Re: Bus Connects Templeogue/Rathfarnham to City Centre Core Bus Corridor Scheme  
Templeogue/Rathfarnham to City Centre

# South Dublin County Council Submission on Bus Connects

Templeogue/Rathfarnham to City Centre Core  
Bus Corridor Scheme.

Land-Use Planning and Transportation Department  
August 2023

*Figure 4 Photograph No. 1: shows a line of trees located along Rathfarnham Castle Park's western boundary wall at the northern end which have not been included within the survey drawing.*

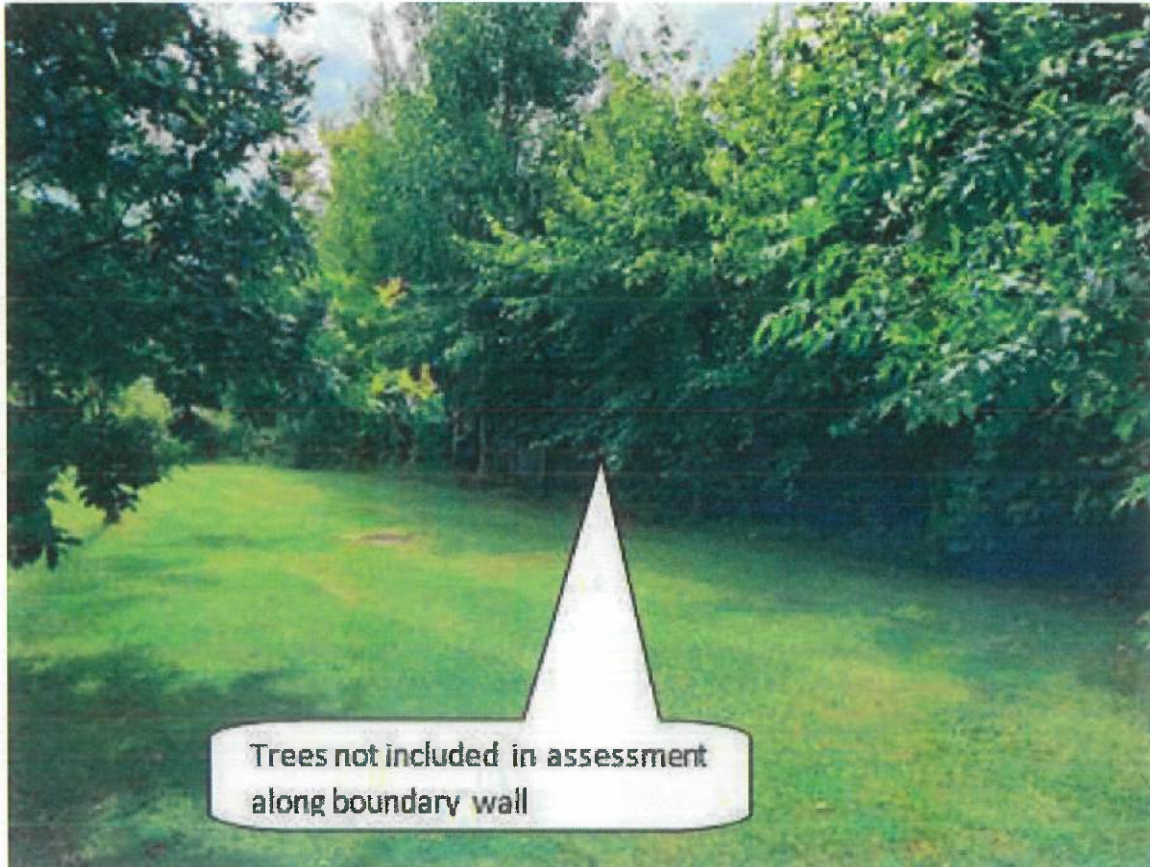
A) With some exceptions the tree survey within Rathfarnham Castle Park has been mainly confined to the land take for the bus connects corridor. There are trees located outside this land take area with root zones that would extend into the site area which have not been mapped or surveyed. Therefore, the impact of proposed works on these trees has not been fully considered or included in the overall impact assessment. Photograph No. 1 (Figure 4 below) shows existing trees that are within the proposed site boundary which do not feature on the survey mapping.

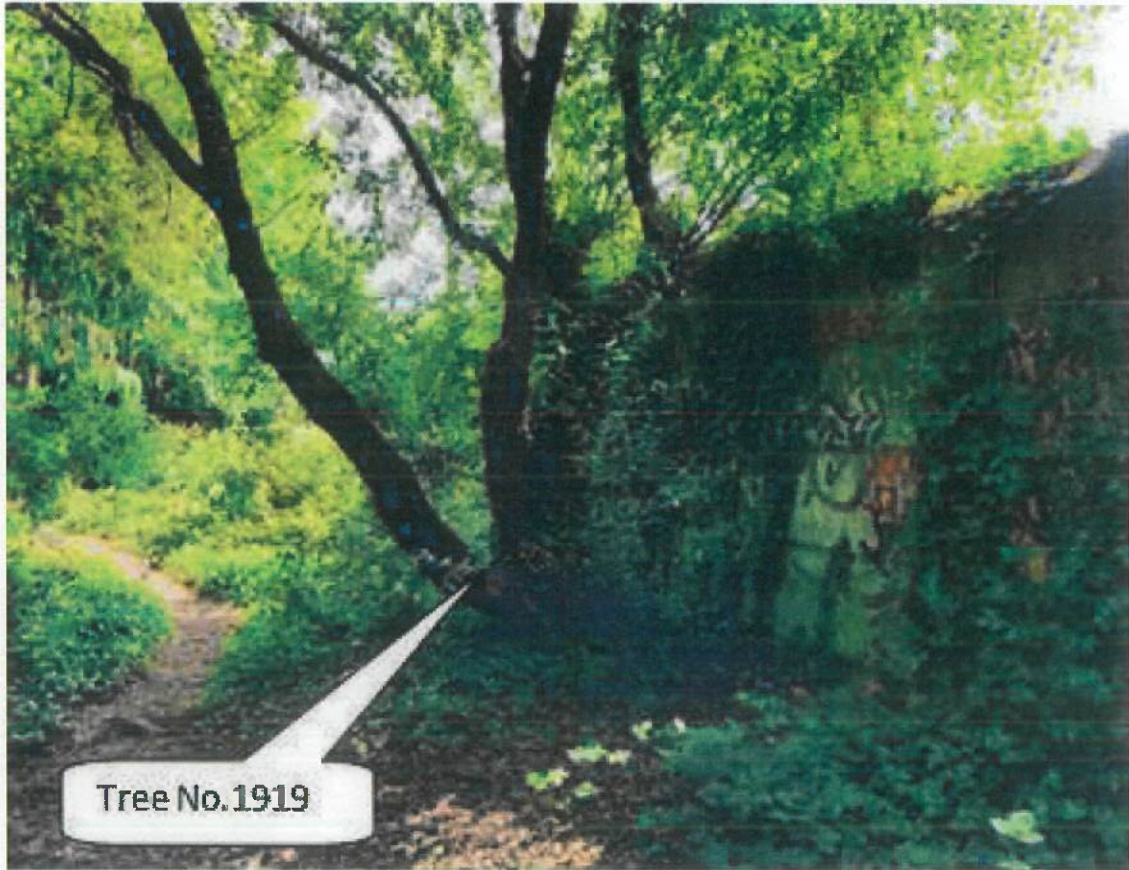
*Figure 5 Photograph No. 2: some of these large size trees are located outside the land take, but would have root zone calculations which would extend into the land take area with possible implications on the health of these trees. Some of these trees have not been picked up on the tree survey or plotted on the topographical survey.*

*Figure 7 Photograph No. 4: One location within Rathfarnham woodland, which has a greater number of trees than the 16 No. trees marked on the tree survey drawing for this location.*

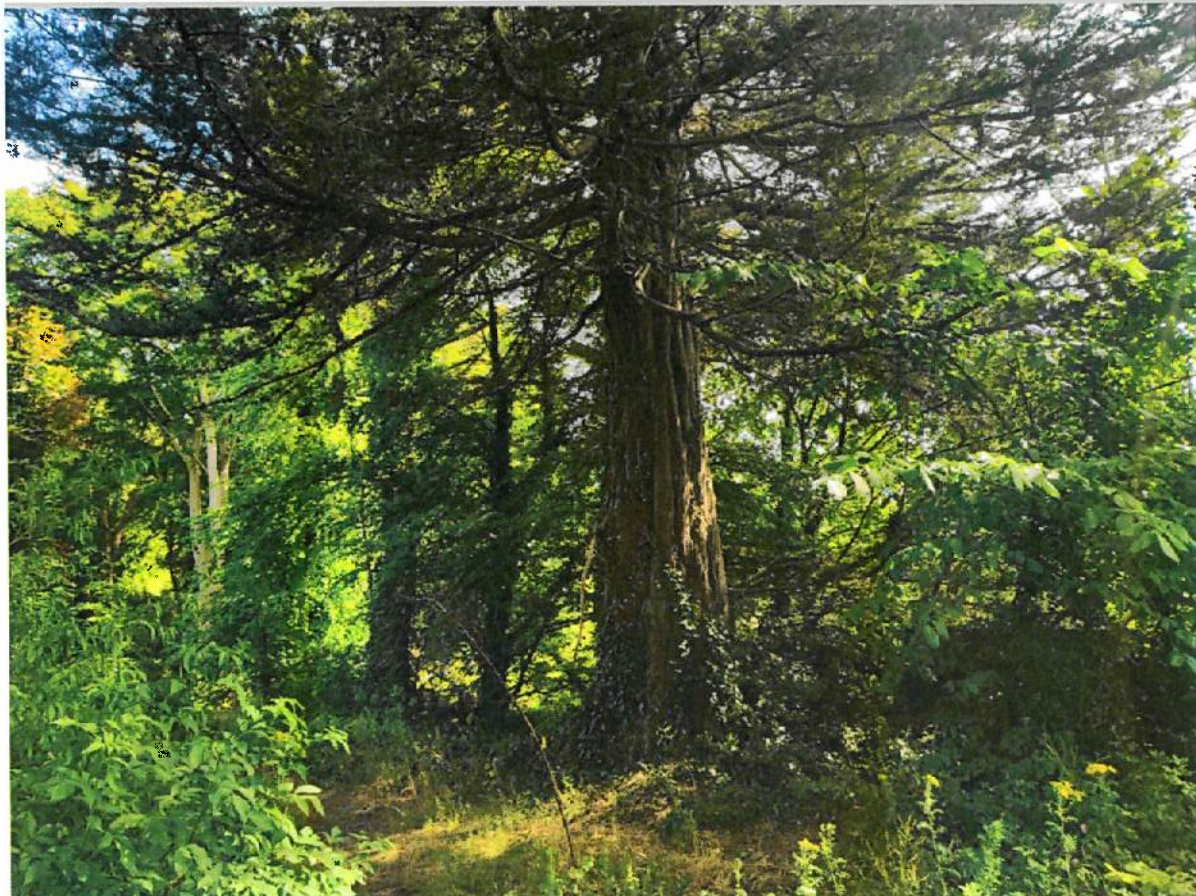
Photographs 4 and 5 (Figure 7 and Figure 8) show the variation in ground levels within Rathfarnham Castle Park that make achieving C) and D) challenging and unlikely in some locations

Figure 11 Construction Compound TR3

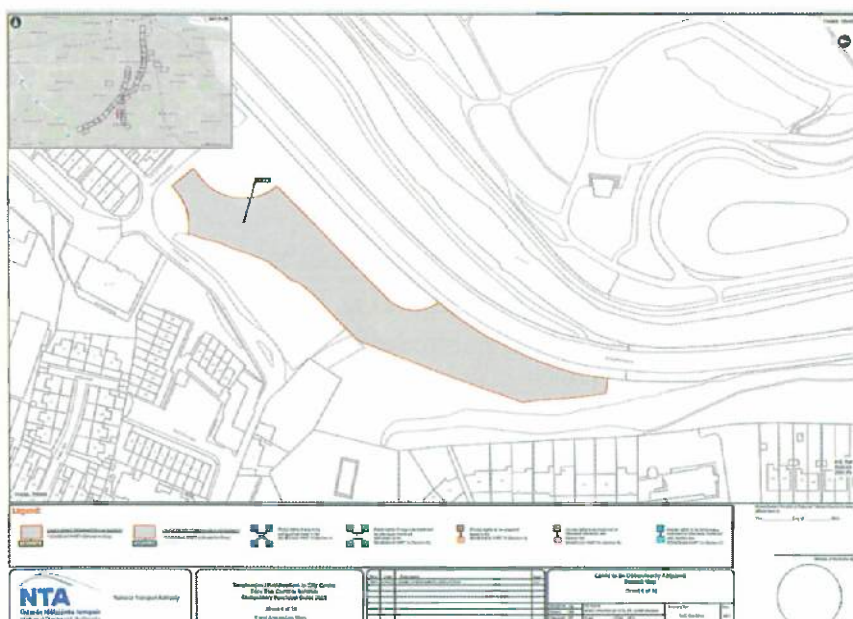
- **Construction Compound TR3:** To be located along Dodder View Road, in the open space area between Dodder View Road, Woodview Cottages and Church Lane. Site extents are limited to avoid any direct impacts on existing trees. (off-chainage). See Figure 11 below:

**Recommendation:**

The proposed compound location above is in the Dodder Valley and is close to the site of an existing term-limited, temporary construction compound where SDCC have agreements regarding full reinstatement of the compound area to planted, landscaped parkland. The above shown extent is excessive and occupies the majority of the usable parkland at this location. SDCC public realm do not recommend ceding of this important location with a temporary CPO. SDCC recommend that the extent of the proposed compound should be limited to the existing compound location on site, and the extent, mitigation and reinstatement measures are to be agreed with SDCC public realm section by local agreement rather than CPO.

Figure 12 Construction Compound TR6

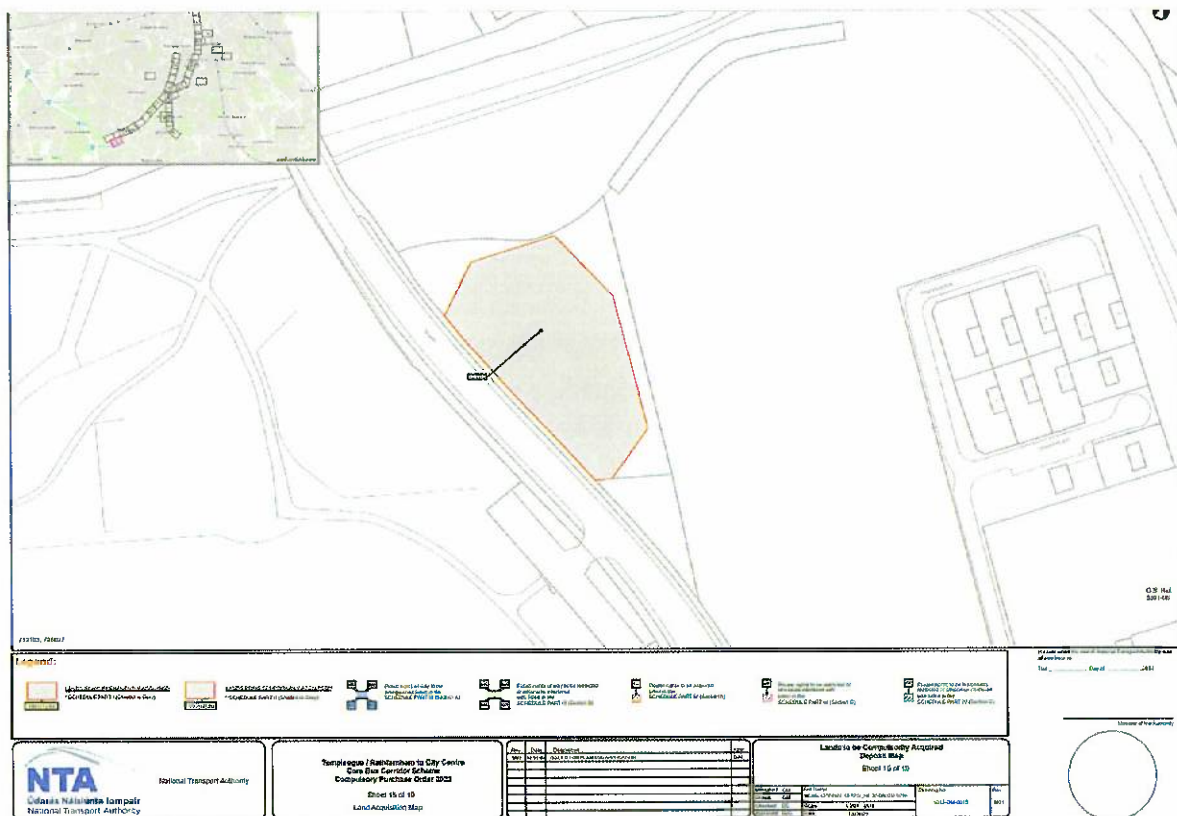
- Construction Compound TR6: To be located on Spawell Link Road, between Spawell Roundabout and Firhouse Road (off-chainage). See Figure 12 below:

**Recommendation:**

This location is in the Dodder Valley and is the site of an existing term limited and temporary construction compound where SDCC have agreements regarding full reinstatement of the compound area to planted, landscaped parkland. SDCC public realm do not recommend ceding of this important location with a temporary CPO. SDCC recommend that the extent, mitigation and reinstatement measures are to be agreed with SDCC public realm section by local agreement rather than CPO.

Figure 14 CPO

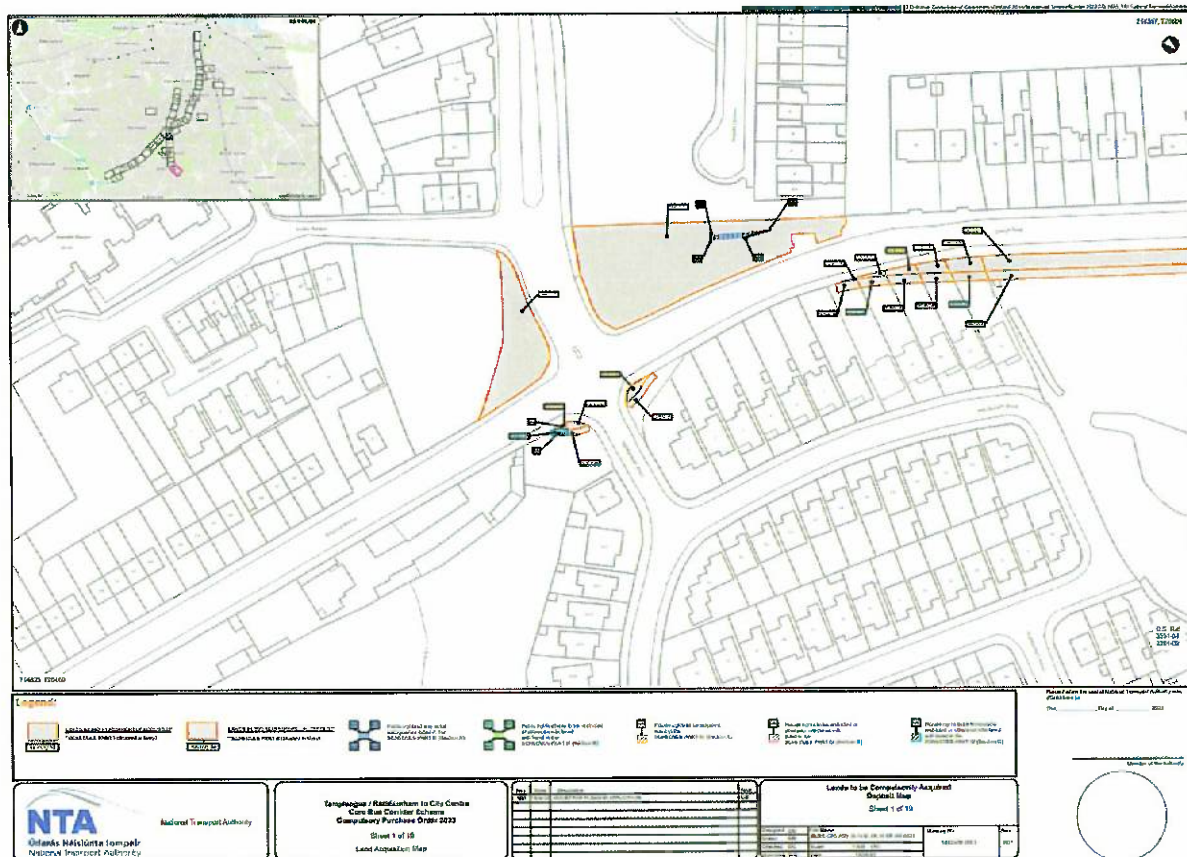
There are a number of CPOs at this junction above, with a proposal to permanently CPO the lands either side of the south side of the junction. It is unclear why this is required; as the areas in question do not appear within the general arrangement or landscape drawing having any permanent NTA related proposals.

Figure 15 CPO

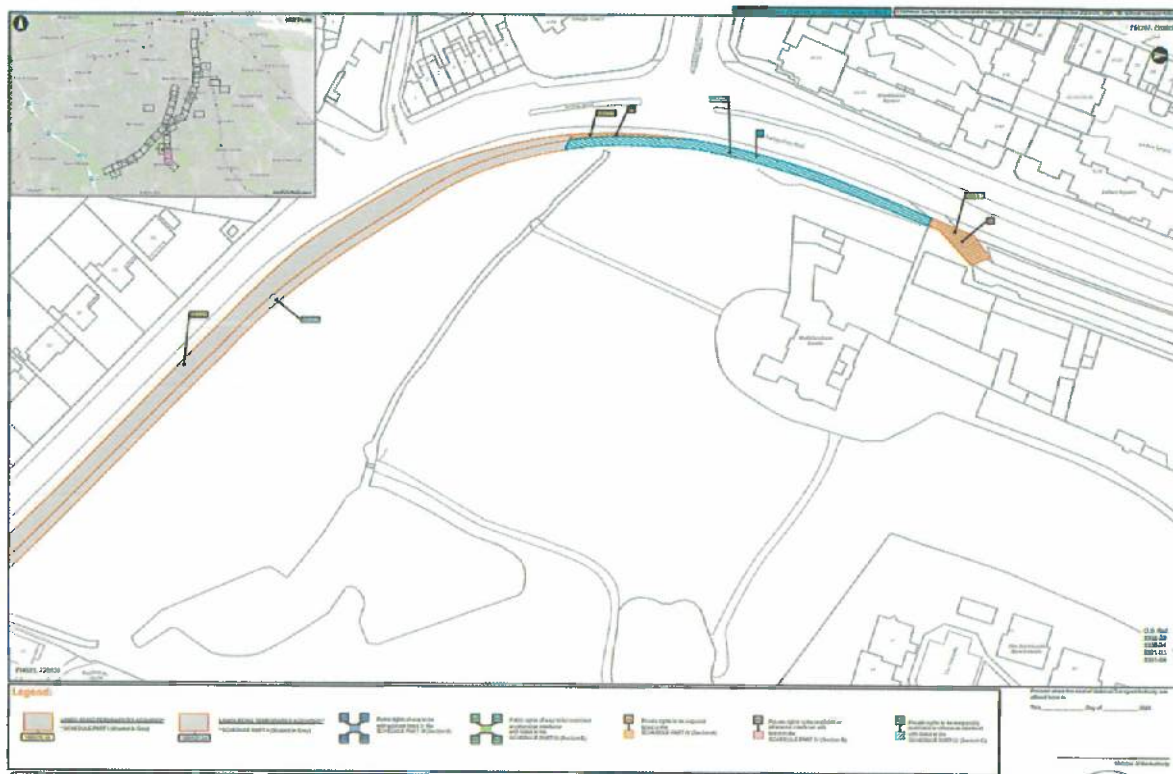
The earlier part of this report documented the significant impact on existing trees at this location, but the loss of parkland and amenity should also be fully considered. There is a significant proposed loss of public parkland at this location with a permanent change of parkland to vehicular carriageway; with little in terms of proposed mitigation:

There is also a proposed temporary CPO of land to build the works impacting on Rathfarnham Castle Park.

Figure 17 CPO

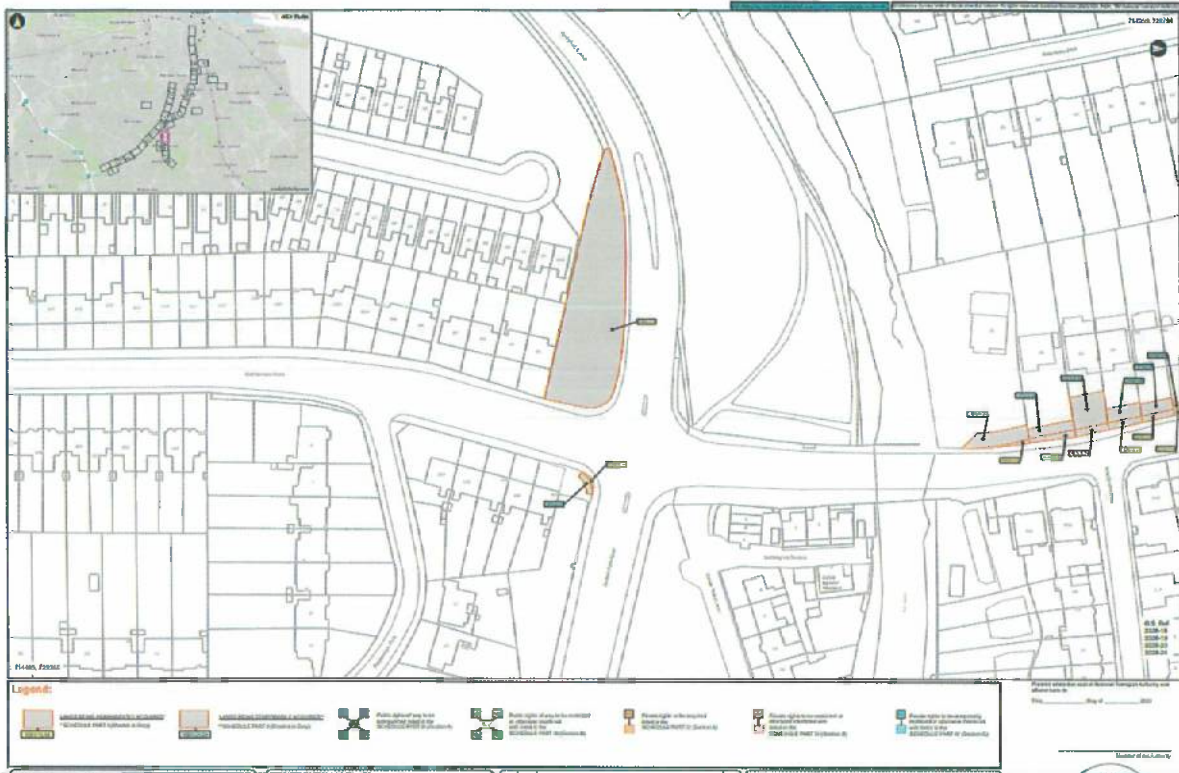
**Dodder Greenway tie-in at Pearse Bridge. Drawing No. 1012-DM-0005 Rev M01. CPO reference 1068 (1).1f.**

SDCC note the extent of permanent CPO at Pearse Bridge location to the south-west of the junction above. The proposal for a permanent CPO at this location is extensive and excessive. There are no proposals on the landscape plan nor in the general arrangement plan that would require NTA to be in control of these lands for any purpose whatsoever. SDCC Public Realm have not been made aware of any requirement for the use of these lands by the NTA.
